APPLICATION FOR PERMISSION
UNDER SECTION 16 OF
THE TOWN PLANNING ORDINANCE
(CAP.131)

A/YEMP/356
14 Aug 2023

臨時公眾停車場 5 年期

App. No.: A/YL-MP/356

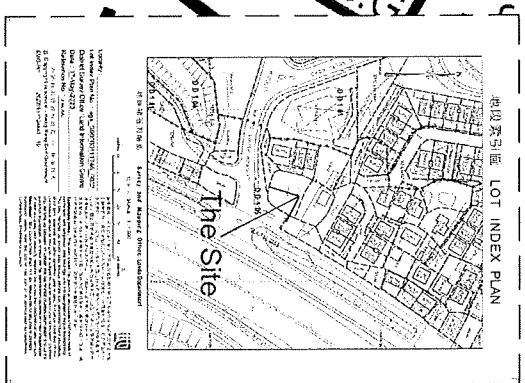
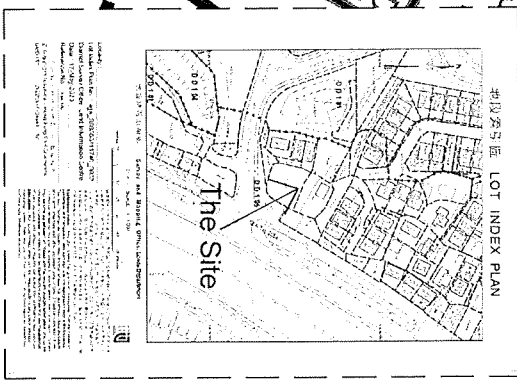
由於停車場之入口位置將會修改，故此車位的分佈及相關的圖則需要修改，現附上修改後之車位分佈圖則給貴處審批，謝謝！

更改臨時停車場的出入口。
由於出入口的改變，車位的排列需要更改。

惟車位的數目不變，亦保持

19個私家車位。

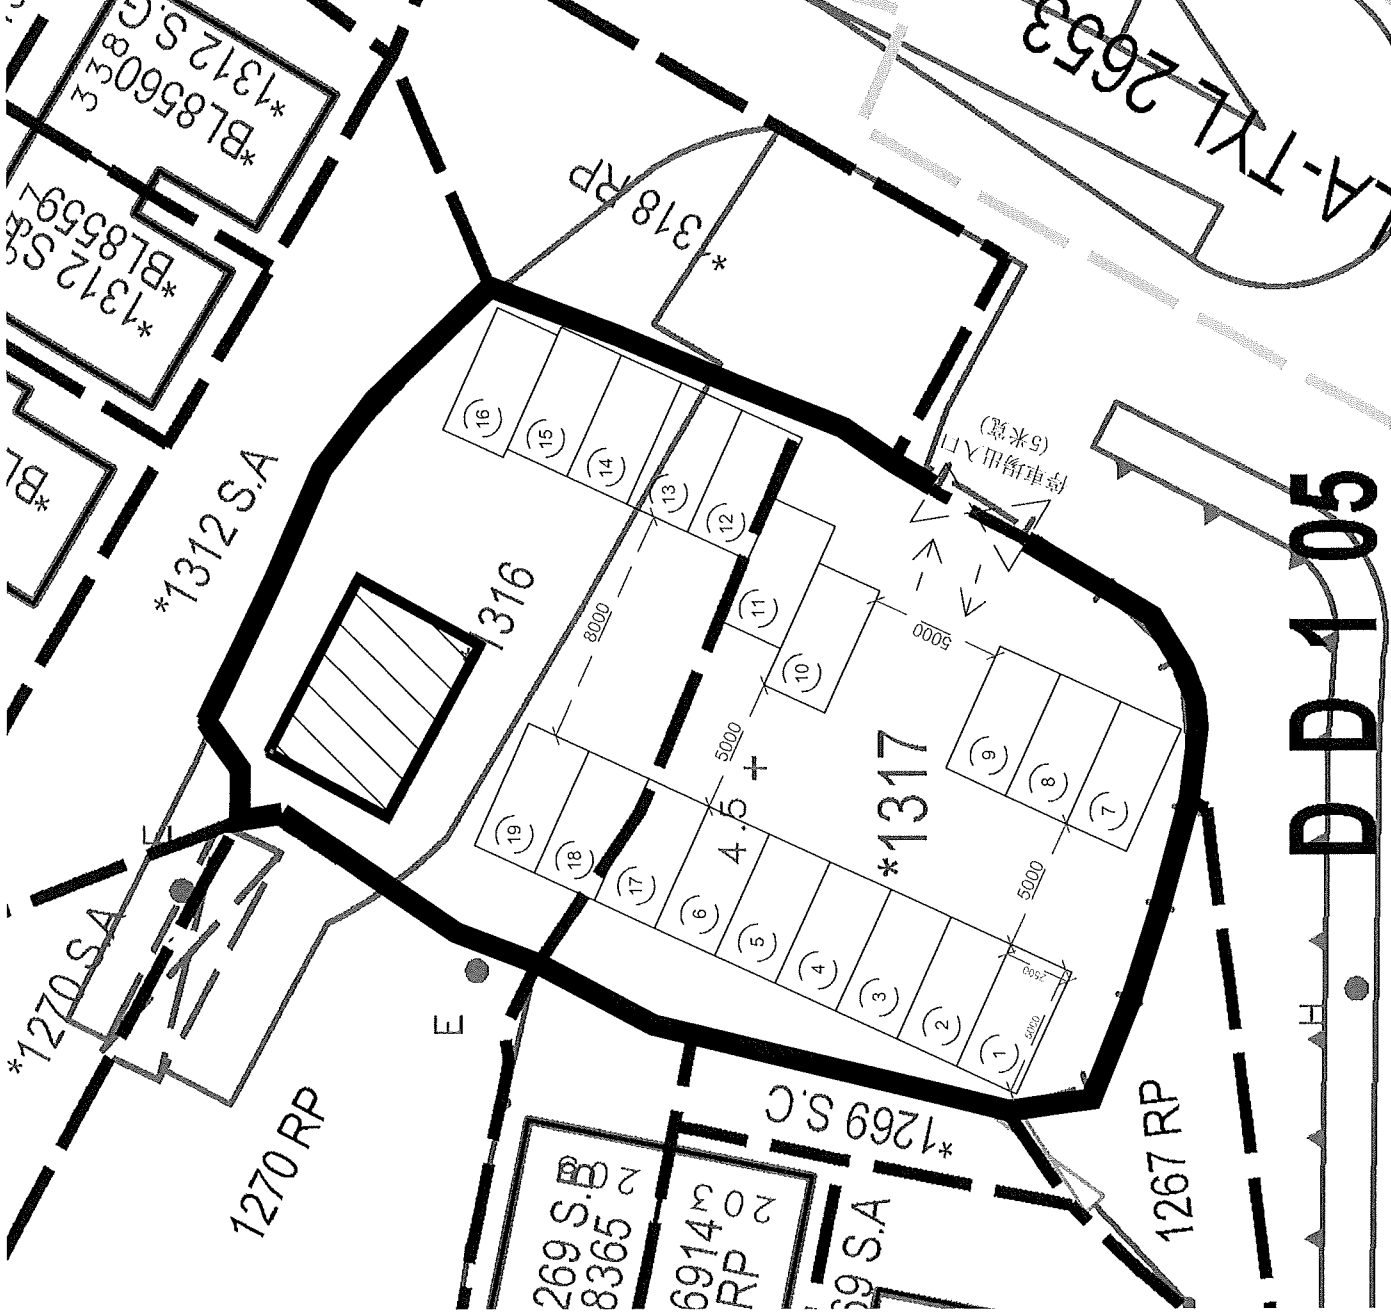
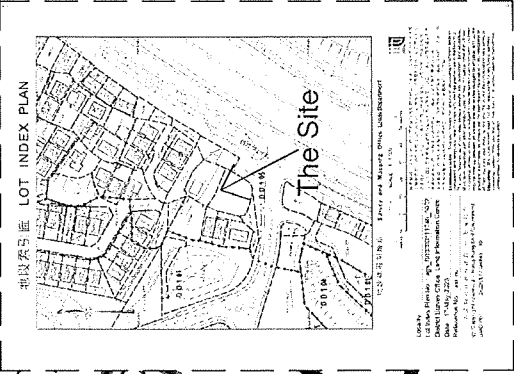
As per TD's comment, we relocated the proposed car park location for your onwards consideration.

- 一 由於上述申請的臨時停車場，基本上的目的是為隔鄰的私人屋苑的私家車作停泊之用，故此日夜時間的出入使用量不高，估計少於 50 駕次。
(附 隔鄰屋苑的照片，以供參考)
- 一 由於上述的車位，僅供私家車使用，故此按行車所需之闊度，現修改泊車位的位置，但車位數目維持 19 個。
- 一 建議的臨時停車場由於為區內人士使用，故此將會 24 小時運作。
- 一 建議的臨時停車位置，為方便泊車，建議如附圖重新分佈。

- 申請地點界線
- 私家車停車位 2.5m x 5m
共 19 個
- 現有舊屋，此地點不是申請
的一部份，申請臨時擬建停
車場5年期不影響其運作。
- 停車場出入口
(5米寬)
